From: [Daniel Cusimano](#)
To: [Scarborough Community Council](#)
Cc: [Gregory Hobson-Garcia](#); [Chris Sakkas](#); [Peter Cusimano](#); [Maziar Ahanin](#); acusimano@cusimanopc.com
Subject: Appln # 18 147401 ESC 36 OZ
Date: September 11, 2019 10:19:48 AM
Attachments: [SCAN.pdf](#)

1478 – 1496 Kingston Road

The Manderley Block

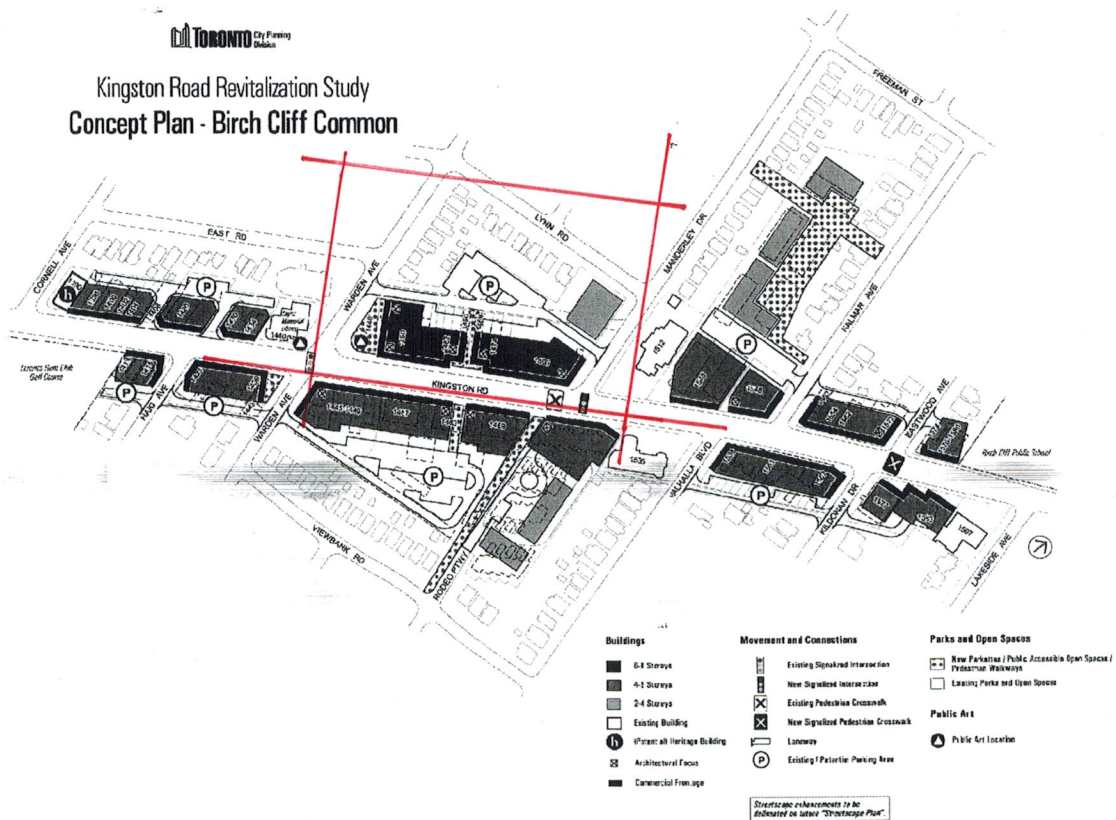
The Zoning bylaw and Urban Design for the “Manderley Block” call for a consolidated plan that is 6 storeys of 20 metres which can be increased up to 8 storeys or 27 metres (see attached excerpts). The proposal from Core Development does not meet any of the criteria and far exceeds the zoning (4.5 is allowed and the current plan is 6.93 which is a 50% increase of what is permitted) and furthermore, at this time the plan has been developed without any consideration for the remainder of the block. We question and want to understand if all of the studies undertaken to support the current Core development have taken into consideration the same built form and density on the remainder of the block? If so, those studies need to be made available in a format that is easily understood by the remainder of the land owners.
